Exhibit C – Plans

DSA 140 and DSA Addendum 01.....73-220

CORONA-NORCO USD TRANSPORTATION OFFICE AT ORANGE GROVE HIGH SCHOOL

100% CONSTRUCTION DOCUMENTS

1 FIBER AND COPPER RISER DIAGRAM

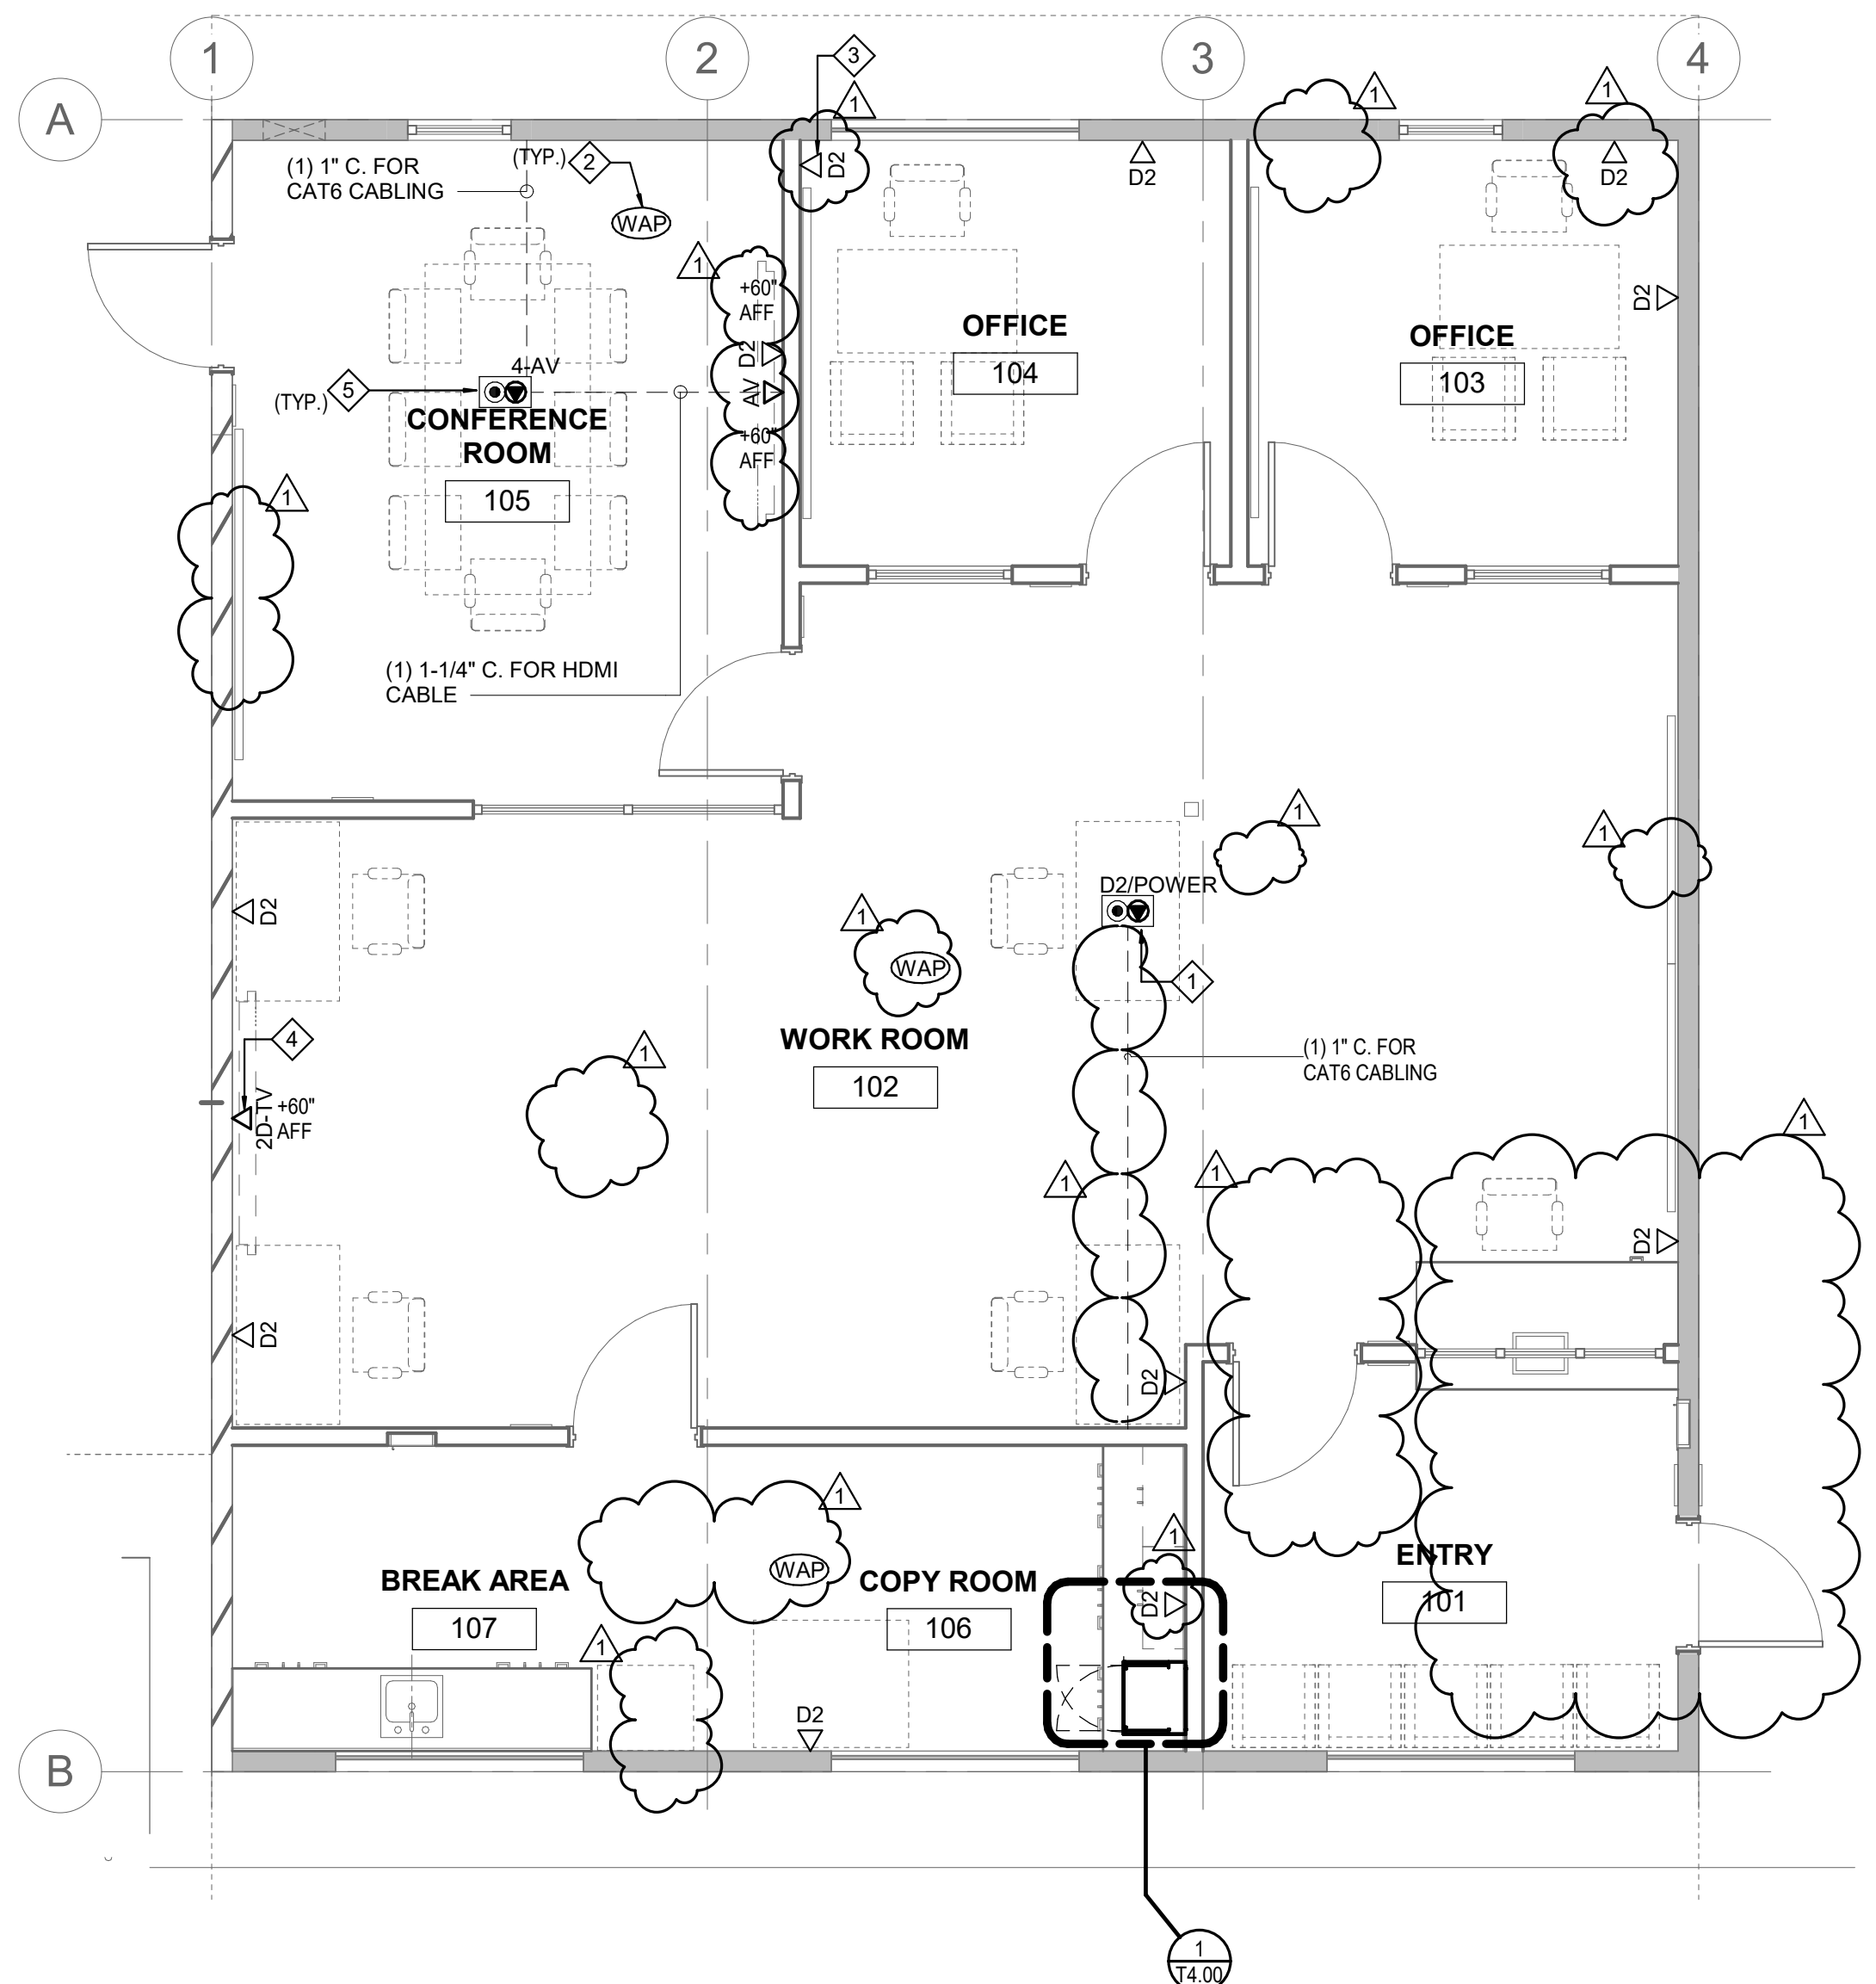
- Item No. 01.29:** **Sheet T1.02:** Removed Detail 1 “Access Control Riser Diagram”.
- Item No. 01.30:** **Sheet T1.02:** Replaced Detail 2 “Fiber and Copper Riser Diagram” in its entirety.

2 PROPOSED FLOOR PLAN
1/4" = 1'-0"

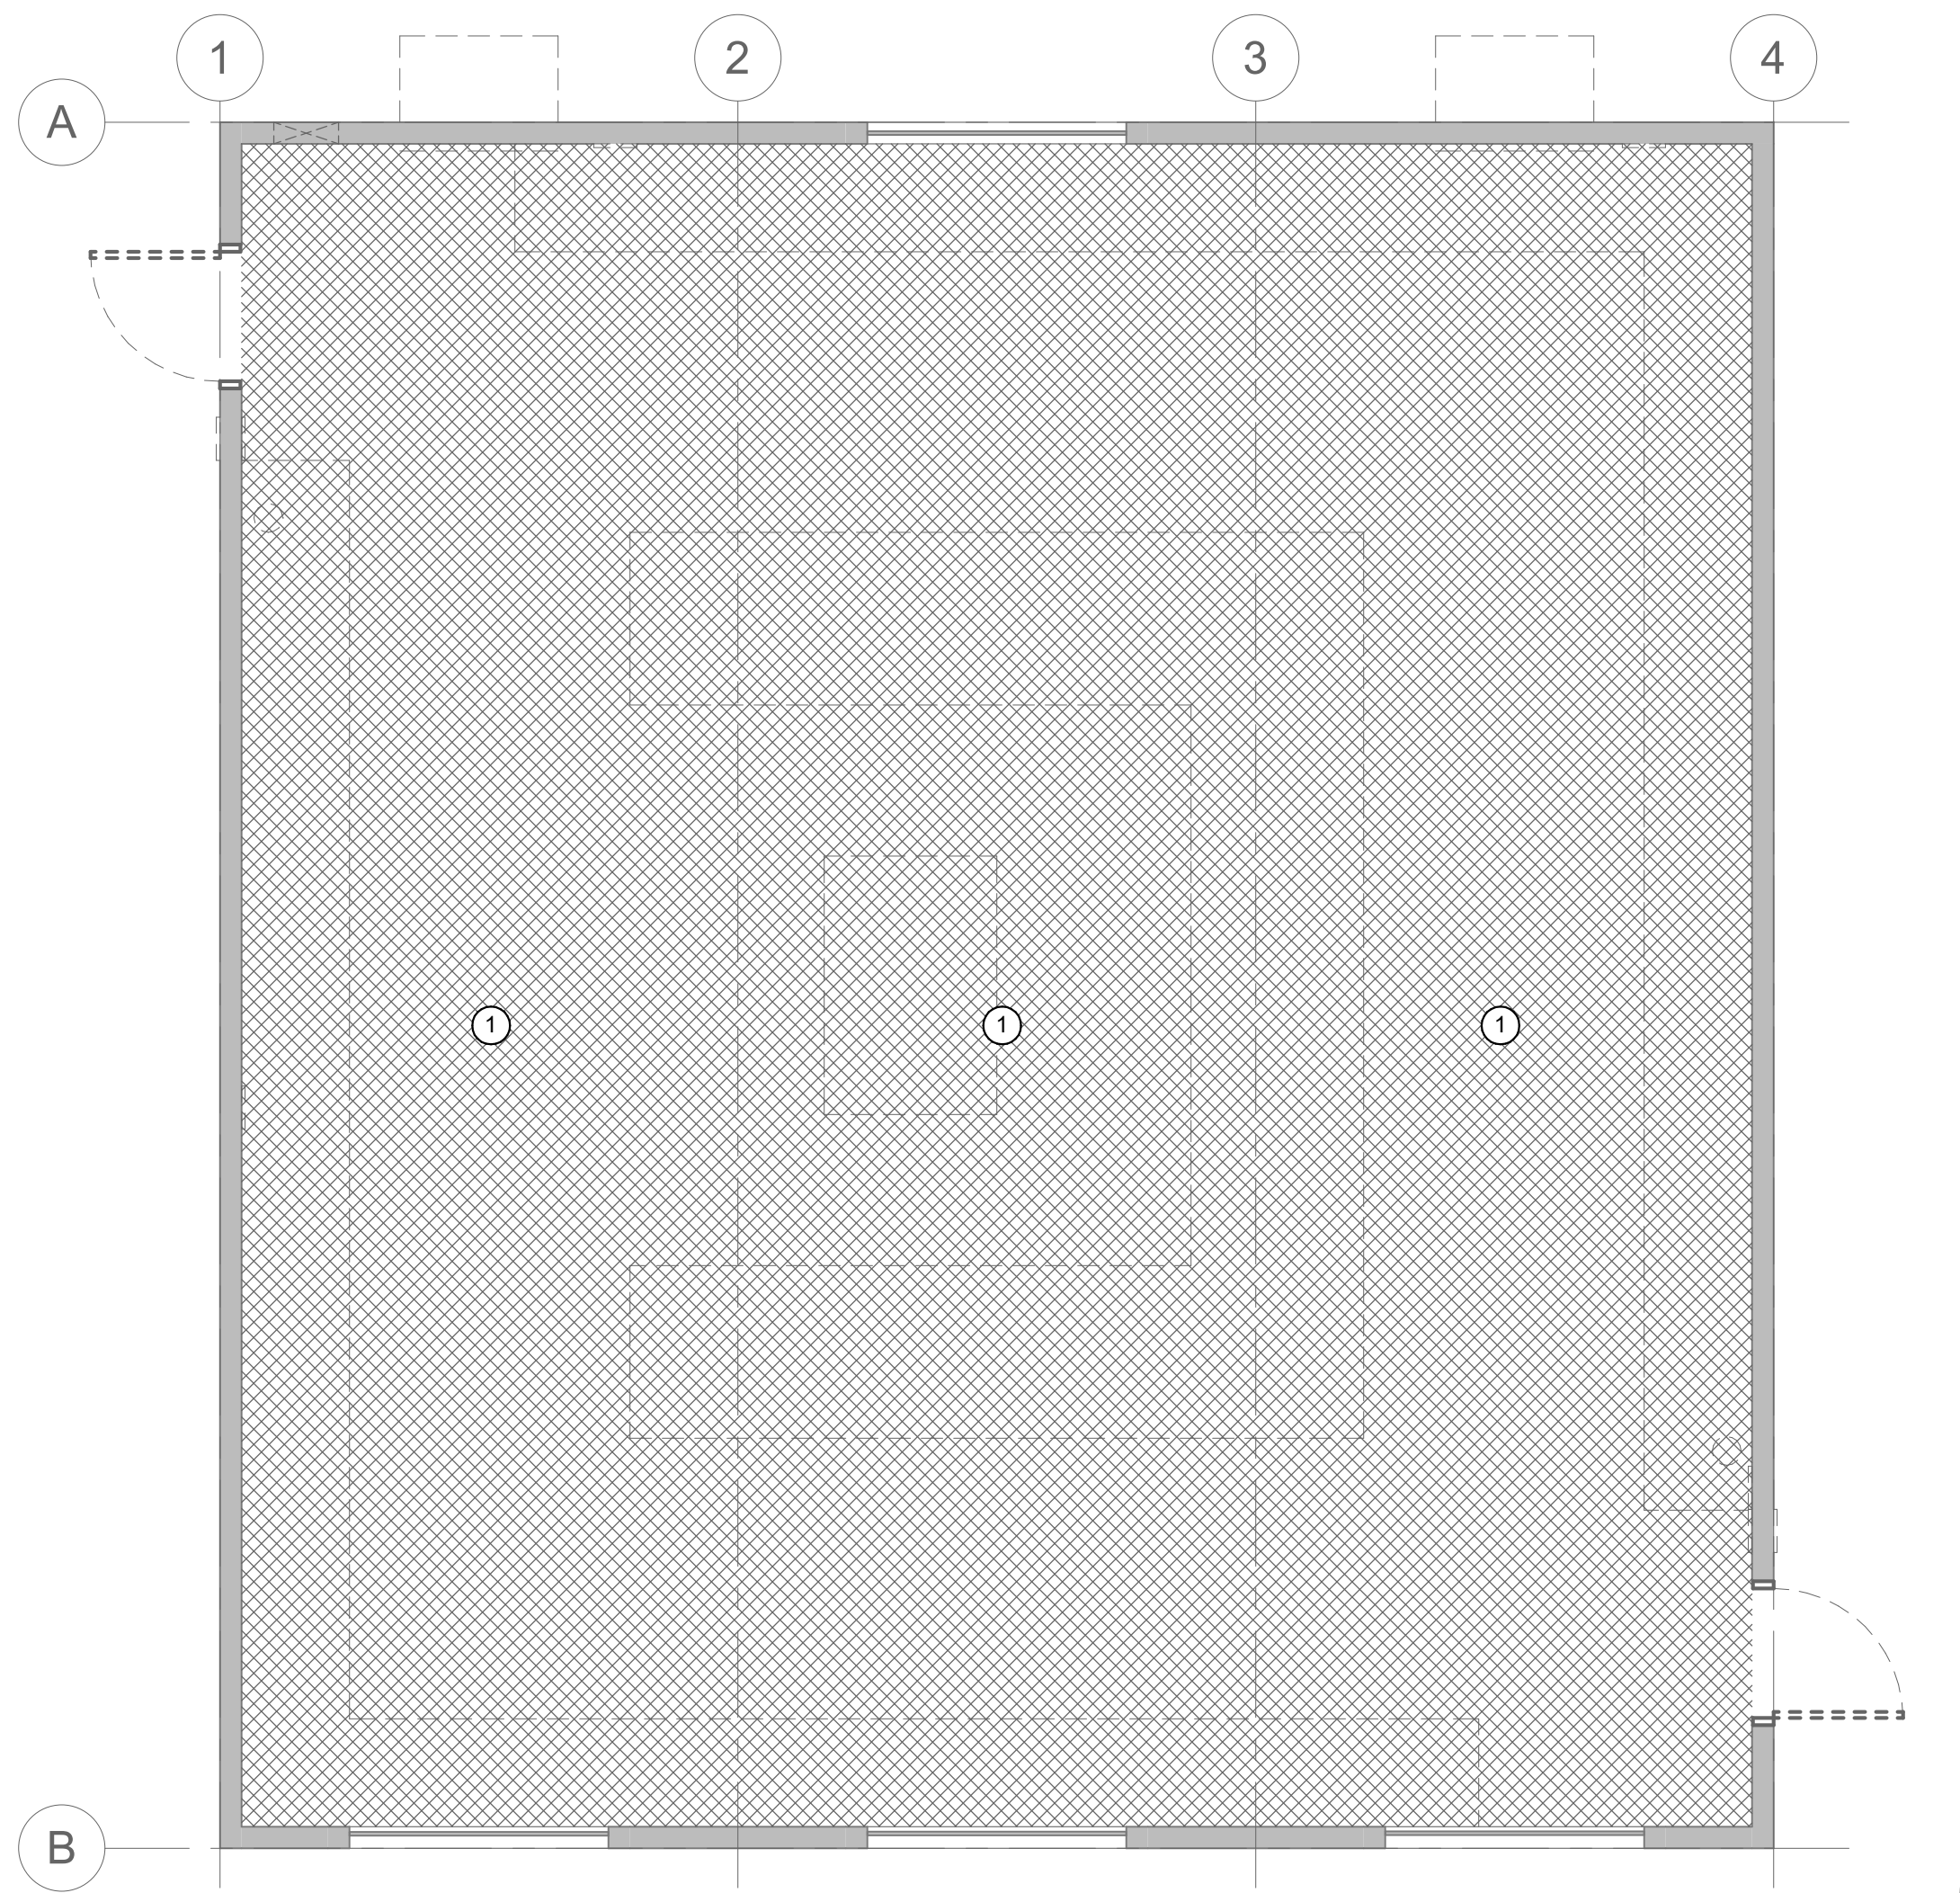
- Item No. 01.32:** **Sheet T2.01:** Revised Detail 2 “Proposed Floor Plan”, WAPS location have been adjusted and data outlet locations have been updated. All card reader scope of work and entrance camera has been removed.

3 WALL CABINET MOUNTING DETAILS
1/2" = 1'-0"

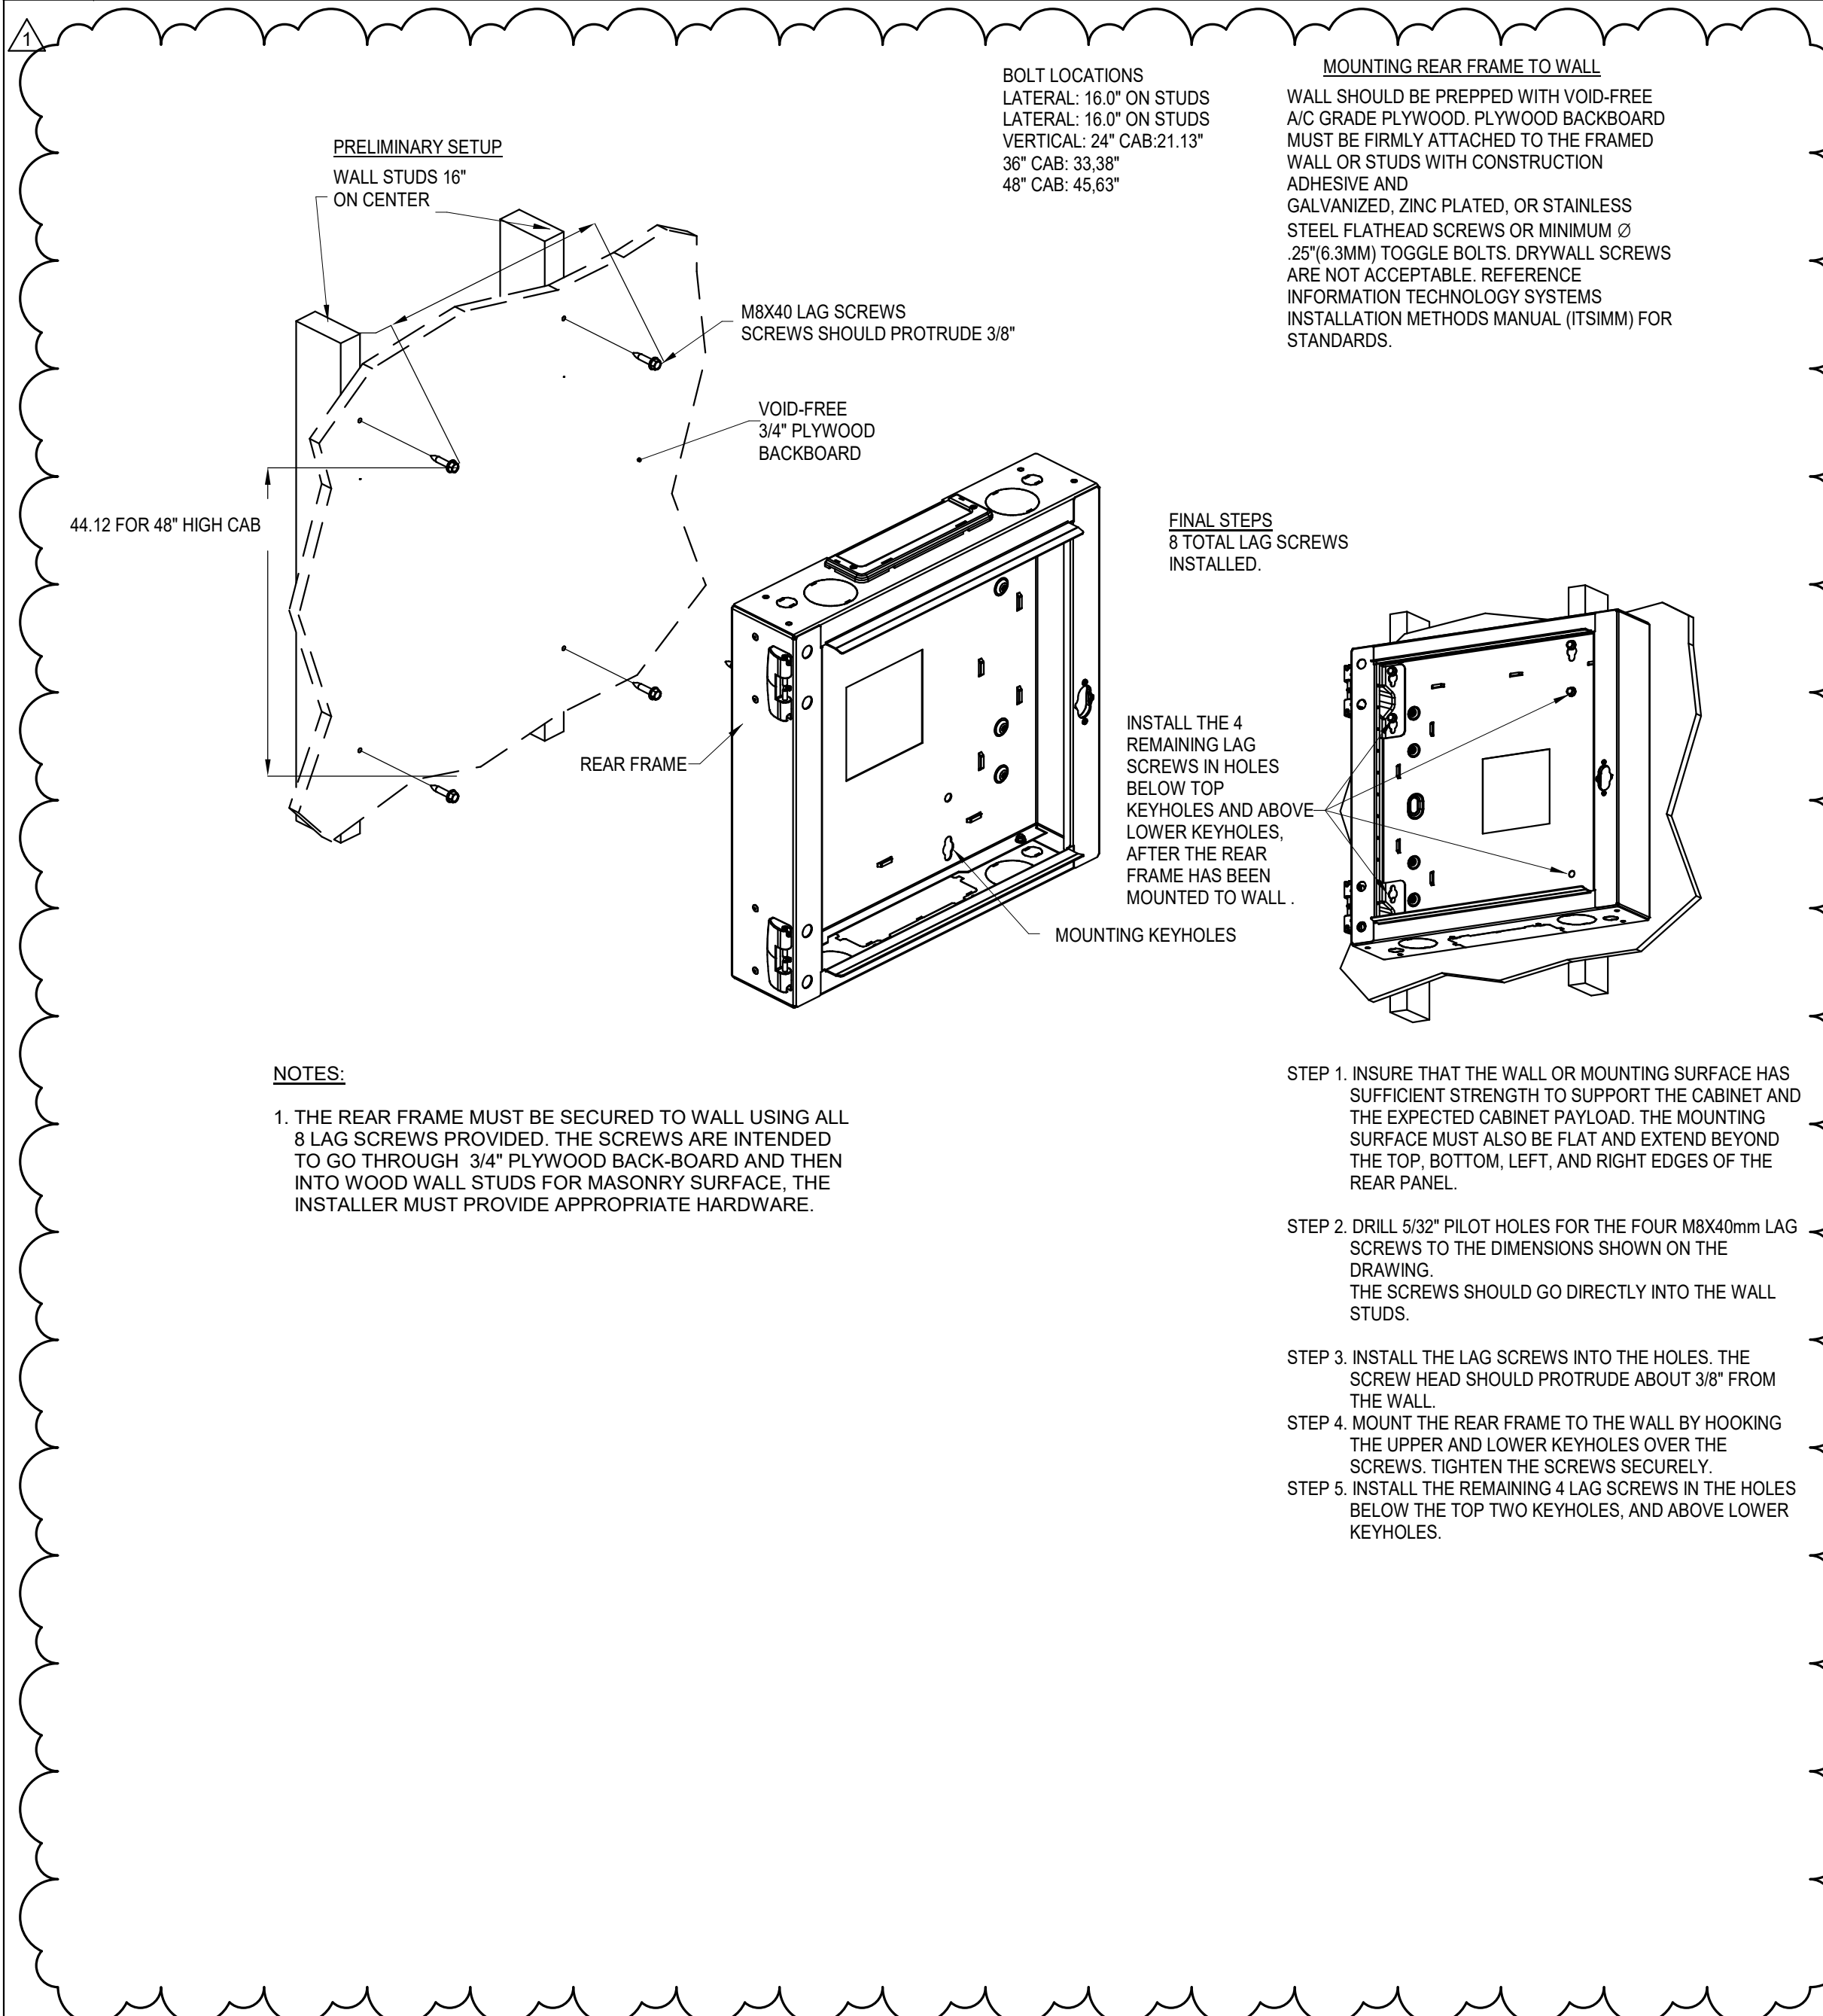
- Item No. 01.35:** **Sheet T6.02:** Added Detail 3 “Wall Cabinet Mounting Details”.
